PROJECT NUMBER
I-35-6(16)166--01-35

PLANS OF ~~PROPOSED~~ IMPROVEMENT
ON THE
INTERSTATE ROAD SYSTEM
FRANKLIN COUNTY
BRIDGES AND CULVERTS
NORTH END OF IOWA NO. 3 INTERCHANGE N.E. 5.6 MILES

CONSTRUCTION PLANS SHOWING PROJECT AS BUILT
Prepared by Logan W. Hotchkiss, P.E. Date 2-27-1976
Res. Const. Engineer
Approved and Forwarded to Ames
Alan L. Simmons Date 5-14-76
District Const. Engineer
After Microfilming Return This Copy to:
D. D. CAMPBELL District Engineer
Prime Contractor:
Contract Amount: $1,407,715.48

Design Sht. N° 1 of 17 File N° 23230 Design N°. 4470

GENERAL PLAN

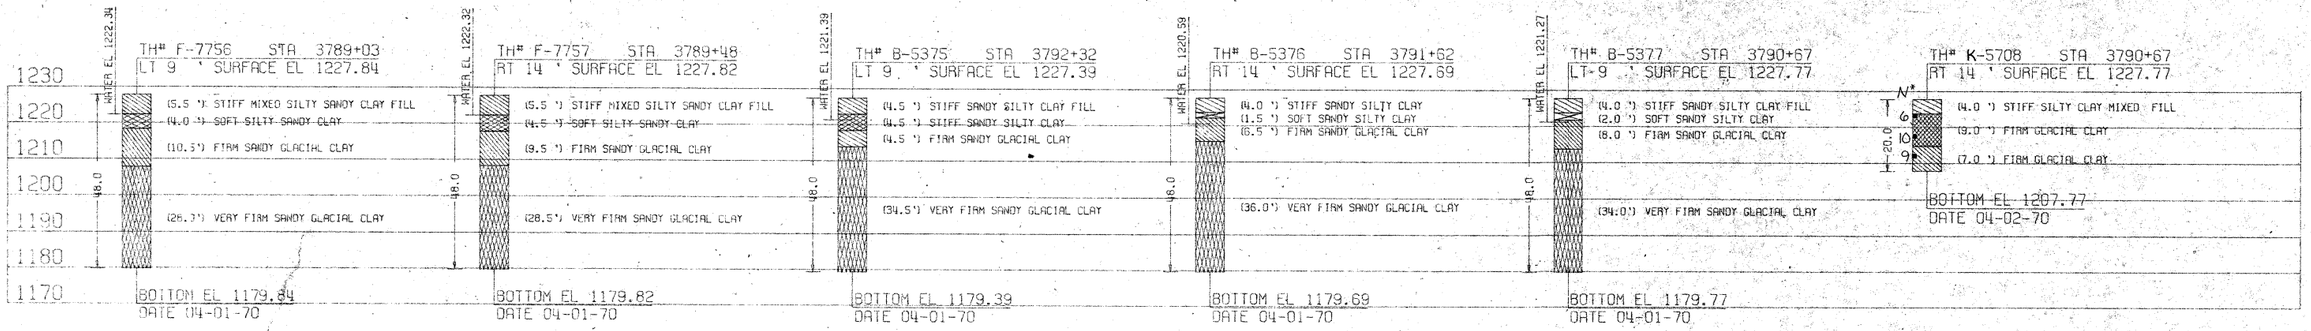
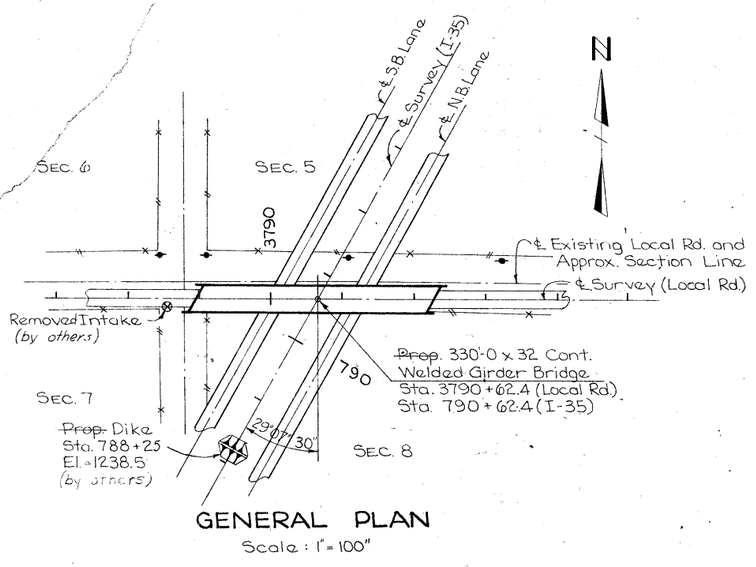
~~Bench Mark N° 60, Sta. 790+13, Lt. 223, Found Lag Bolt S. Side Tel. Pole, Elev. = 1231.14.~~

Bench Mark No. 94, Sta. 3792 + 25, 17' Lt. I.S.H.C. Marker in North East Curb County Road Bridge Elev. 1261.22

REAR ELEVATION (PILES NOT SHOWN)

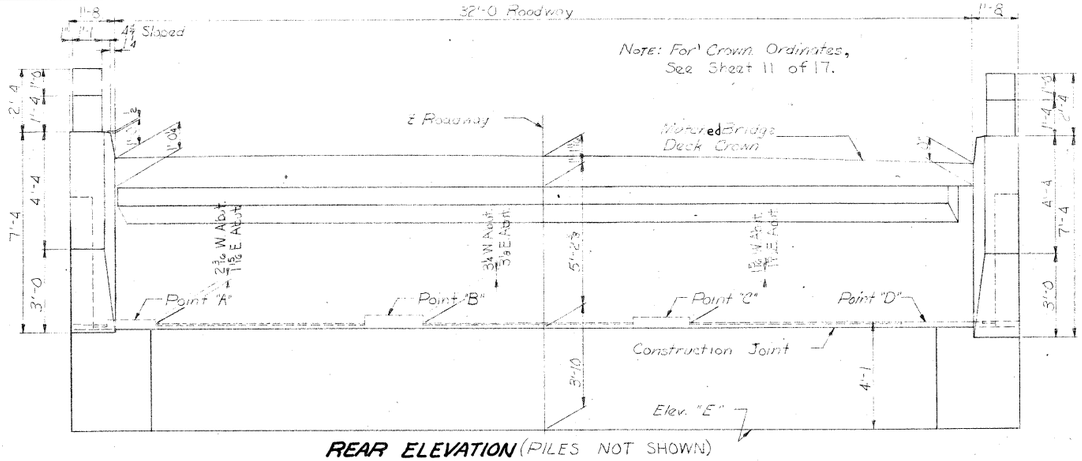
BENCH MARK: ~~No 60, Sta 790+5, 223' Lt., Found Lag Bolt in S. Side Telephone Pole, Elev = 231.14~~ Elev. 1261.22

No. 94, Sta. 3792+25, 17' Lt. I.S.H.C. Marker in North East Curb County Road Bridge.

PILE PLAN

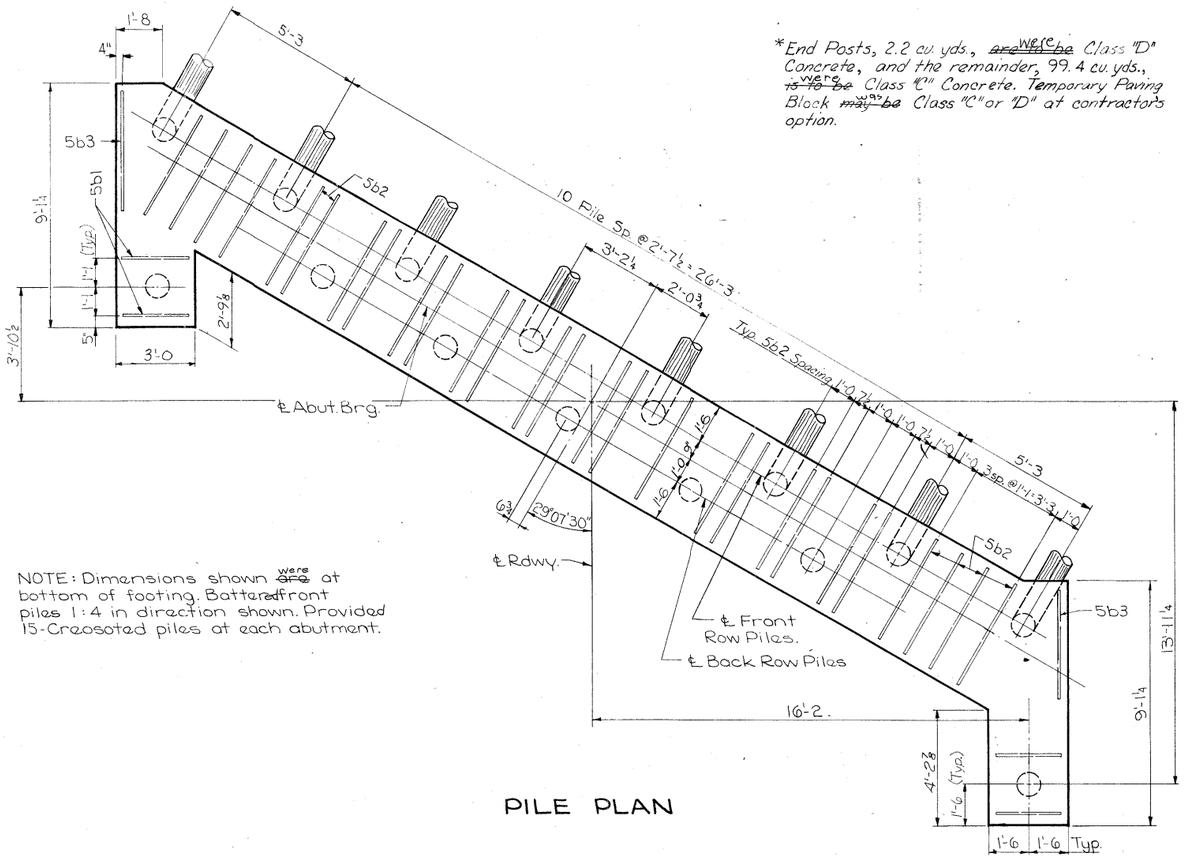
Item	Unit	W. Abuts	E. Abuts.	Total
*Structural Concrete	C.Y.	50.8	50.8	101.6
Reinforcing Steel	Lbs.	5,846	5,846	11,692
Class 20 Excavation	C.Y.	58	58	116
Granular Backfill	C.Y.	80	80	160
Creosoted Piling	L.F.	~~15 @ 45'~~ 15 @ 55'	~~15 @ 45'~~ 15 @ 55'	~~1350~~ 1650

TOP OF SLAB ELEVATIONS

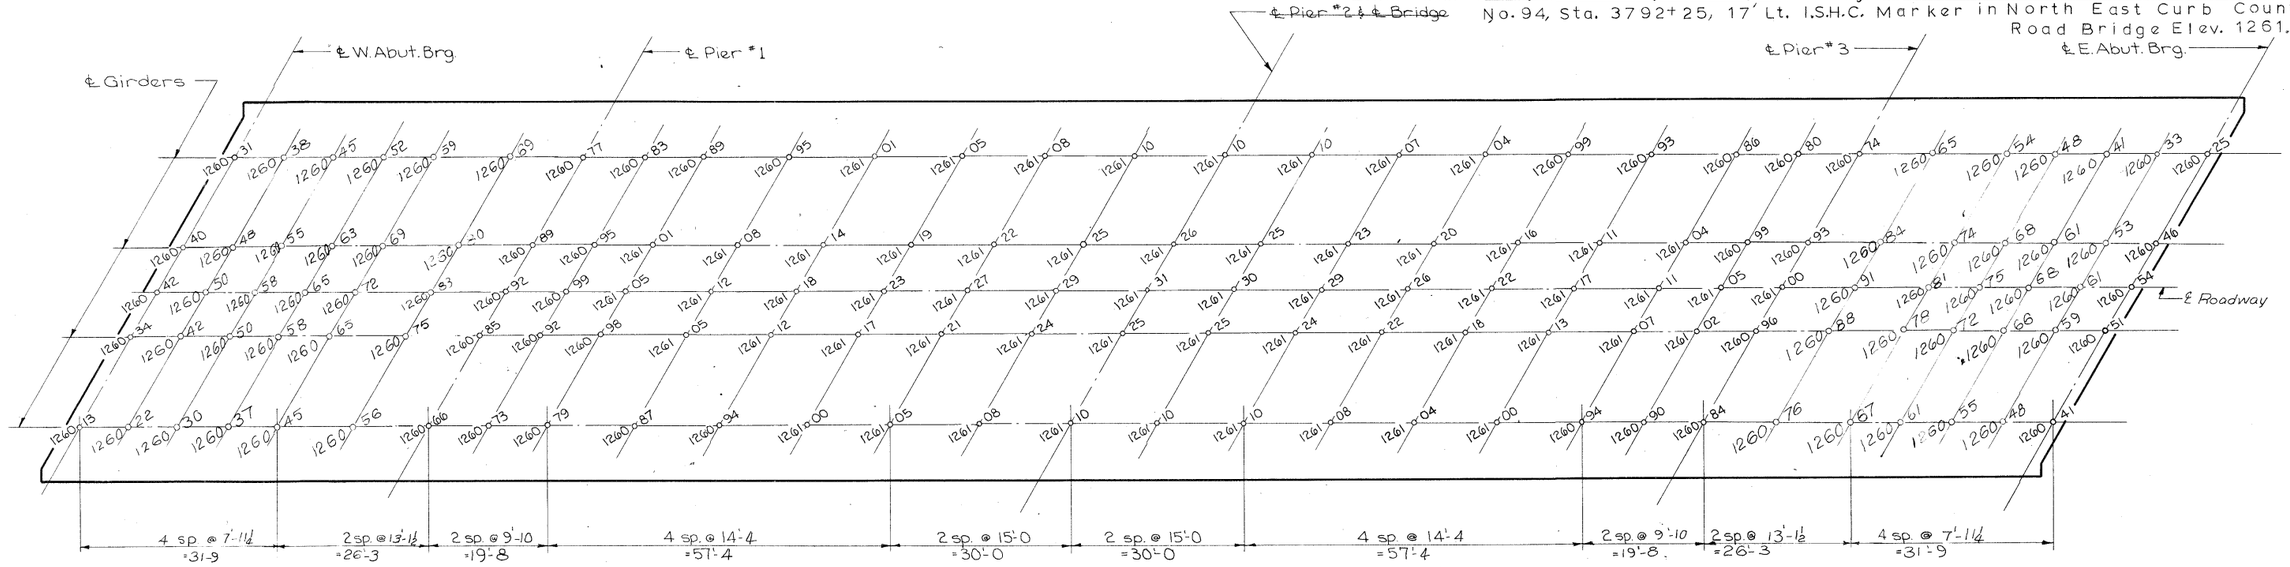
BENCH MARK: ~~No 60, Sta. 790+13, 223' Lt., Found Lag Bolt in S. side Telephone Pole, Elev. = 1231.14.~~ No. 94, Sta. 3792+25, 17' Lt. I.S.H.C. Marker in North East Curb County Road Bridge Elev. 1261.22
